**Cross Alameda Trail
Ralph Appezato Memorial Parkway Improvements**

PROJECT NUMBER P.W. 03-18-11

ADDENDUM NO. 06

Attachments: **New Service Irrigation Schematic and AMP Details**

TITLE : TYPICAL TRENCH SECTION DETAILS				
DRAWN :	L.V. ANCHETA	DATE: NOV. 24, 2009	DWG. NO. :	REV.
REVIEWED:	[Signature]	[Signature]	1-L-412	6
APPROVED:	[Signature]		SCALE : NTS 6 1/8" = 1"	1 OF 1

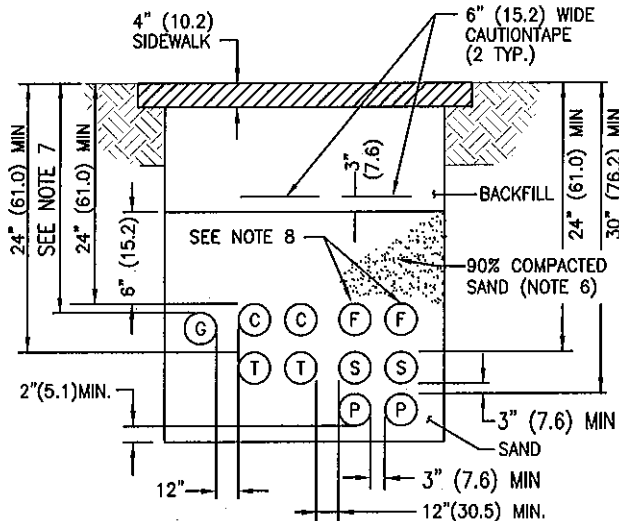
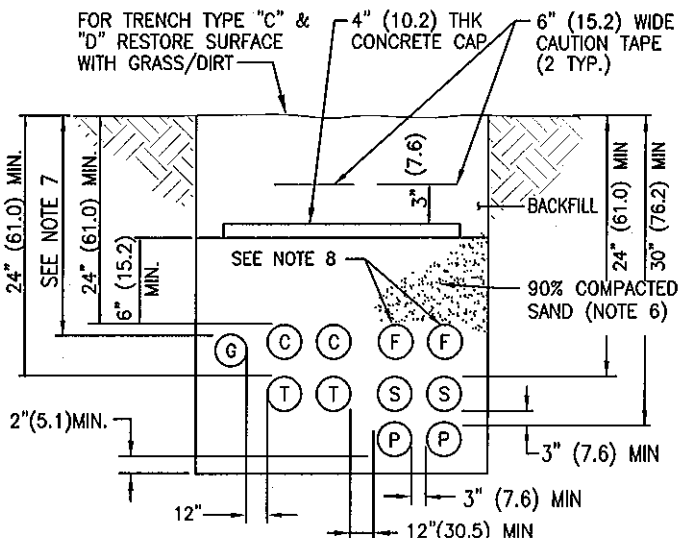
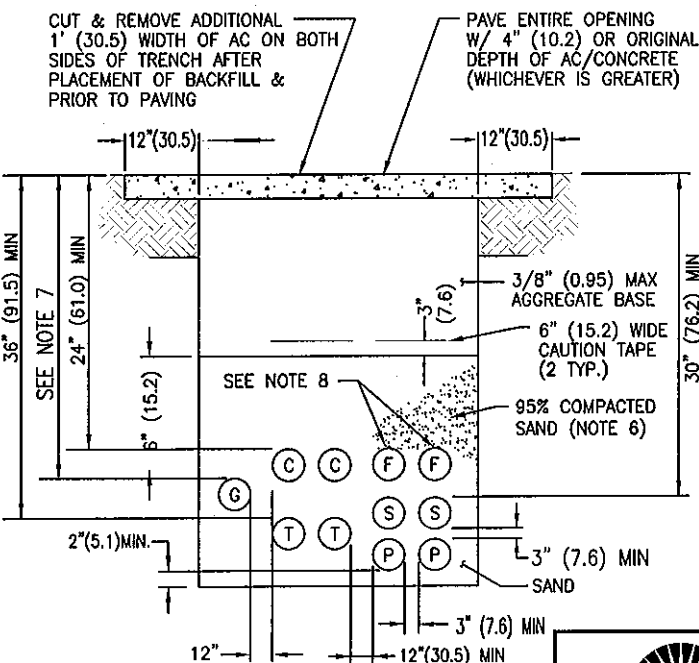
1) Question: Where will power come from for the irrigation control if the lighting bid alternate is not executed?

Answer: Power shall be drawn from the existing box approximately 125 feet south of the project. Contractor shall trench through existing sidewalk to the location of the existing box and construct a trench according to AMP standards. The trench shall be installed according to AMP detail 1-L-412 contain the following (4) -4" conduits. One conduit shall contain a #2 conductor for service. One secondary box shall be provided and installed by the contractor as well as a service conduit to the pedestal. The contractor is responsible for the pedestal and AMP will provide the meter. The contractor shall also provide the service downstream of the meter to the (N) irrigation controller. Please see Addendum 4 for approximate location of the irrigation meter. The contractor shall provide saw cutting, demolition and off haul necessary to perform this work. For bidding purposes it is anticipated that approximately 500 square feet of (N) Alameda concrete sidewalk will need to be installed by the contractor. Also note that this item will only be executed if the lighting bid alternate is not selected by the City. This will require the contractor to provide a stub to the future lighting anticipated for the plaza. See sketch below of Sheet IR-1 for more information and attachment with pertinent AMP standards. This works shall be paid under the irrigation lump sum item #120.
